## **Response to Comments**

**Modification of the *Hanford Facility*  
*Resource Conservation and Recovery Act*  
*Permit for the Treatment, Storage, and*  
*Disposal of Dangerous Waste, Part III,*  
**Operating Unit Group 10 (WA7890008967)**  
**Waste Treatment and Immobilization Plant**  
**September 2 – October 20, 2014****

Comment period: *Waste Treatment and Immobilization Plant (WTP) Design Changes, September 2 – October 20, 2014*

**Figure 1:  
(Conceptual Design)**

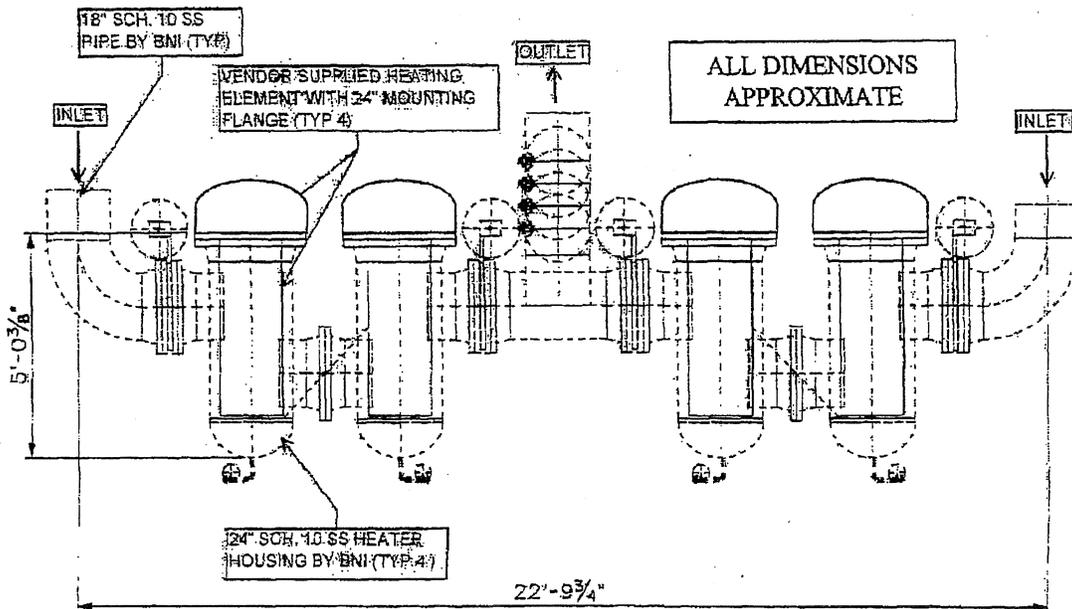
- A check of the Mechanical Data Sheet (24590-CD-POA-MEE0-00003-15-0007, Rev 00C) indicates that the vendor was only told that the process input was dry air, steam, and “other.” The lethal concentration of NO<sub>x</sub> gases was omitted.

*Your comment details your concerns related to the Corrosion Evaluation and the Mechanical Data Sheet included in the package. Ecology reviewed the technical and quality control issues documented in your letter. We also discussed these issues with DOE-Office of River Protection (ORP) and Bechtel National Inc. (BNI).*

24590-CD-POA-MEED-00003-05-00004 Rev 000H

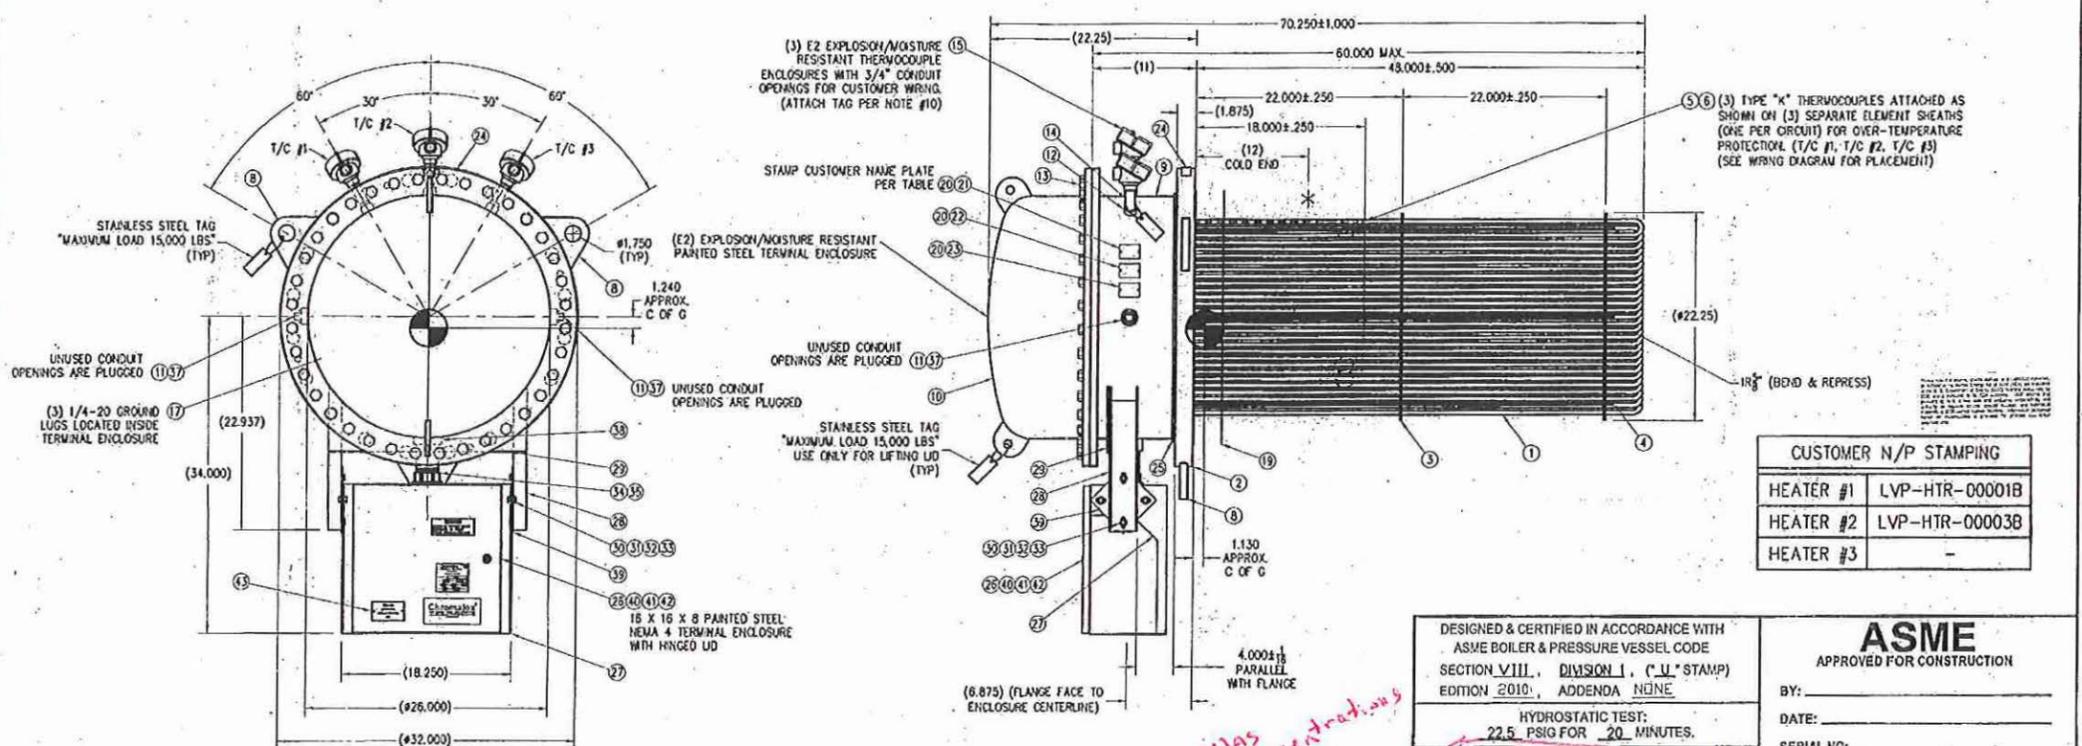
In spite of this the vendor drawings (24590-CD-POA-MEE0-00003-03-0004, Rev 00H and 24590-CD-POA-MEE0-00003-03-0005, Rev 00I) both show in the Design Data Box that the process gas is “air” (not process gas) and each has a check box that is clearly marked that there are no “lethal substances.” Contrary to the check boxes, NIOSH has established that the “immediately dangerous to life and health” (IDLH) concentration for NO<sub>2</sub> is 20 ppm<sub>v</sub> and the IDLH for NO is 100 ppm<sub>v</sub>. The incoming gas to the heaters is therefore more than 285 times the lethal concentration. The vendor did not seem to be aware of this when selecting their equipment. As a result, it may not be fit for hazardous chemical service. The vendor did not list the acid gases or chloride present in the corrosion evaluation either. The NIOSH web page is <http://www.cdc.gov/niosh/idlh/intridl4.html>.

- The Corrosion Evaluation noted on page 1 that type 304-L and Carbon Steel are unacceptable materials. The Mechanical Systems Data sheet indicates this is a Quality Level “Q” procurement. The two vendor drawings provided to Ecology, however, each

only included the first of three sheets. The first sheet notes that the “bill of materials” is located on Sheet #3, which was not part of the package submitted to Ecology. So it is impossible verify if appropriate materials were used or if commercial grade materials were qualified for a “Q” application. Resistance of small parts to the oxidizing environment of the NOx appears to have been ignored, at least in the mechanical systems data sheet. This leaves the construction of the heaters open to question.

SEE SHEET #3 FOR BILL OF MATERIALS

*BNI had previously committed to providing to Ecology a revised Process Corrosion Data Sheet (PCDS) with the Corrosion Evaluation submitted with this package. However, Ecology found that the Corrosion Evaluation did not include the latest version of the PCDS. BNI has informed us that the Corrosion Evaluation is being updated with new calculations and will be presented in a new format.*

*We recognize that the original package submitted was incomplete. We will make sure all the technical concerns are addressed and resolved with the permittees before re-issuing the LAW-026A package for public review.*

BECHTEL NATIONAL  
 PROJECT: RPP-WTP  
 PROJECT NO.: 24590  
 PO NO.: 24590-CD-POA-MEO-00003, REV. 0  
 EQUIPMENT NO.: LVP-HTR-00001A, LVP-HTR-00003A  
 LOCATION: RICHLAND, WA

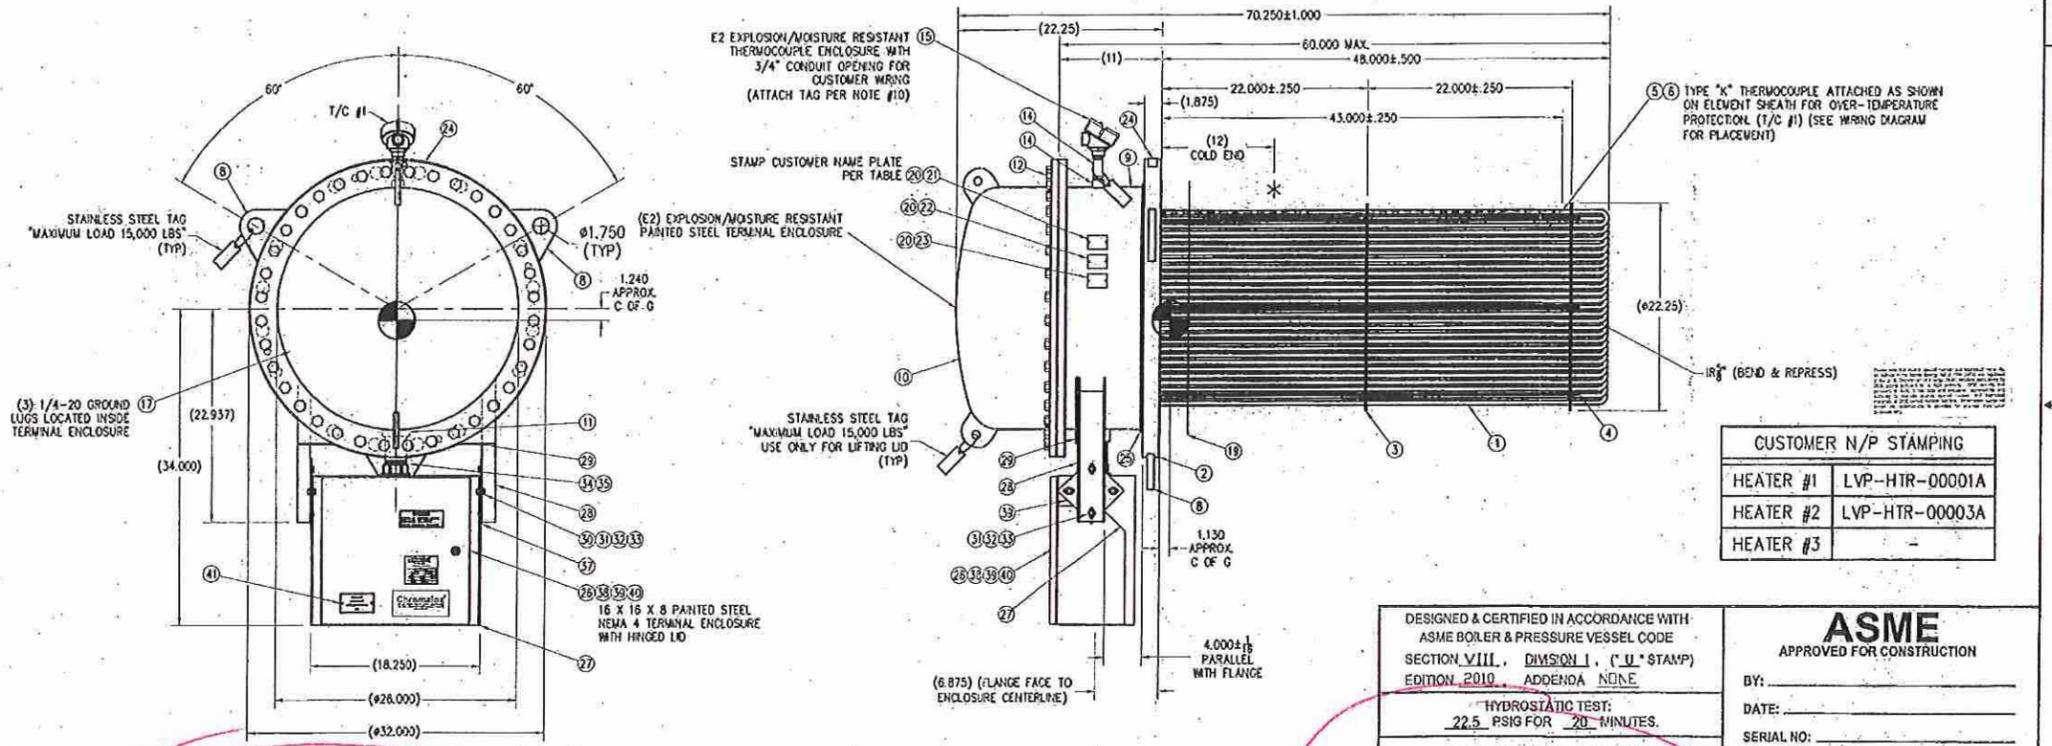
SHEET 2 & 3  
 are missing  
 from the  
 Permit Package
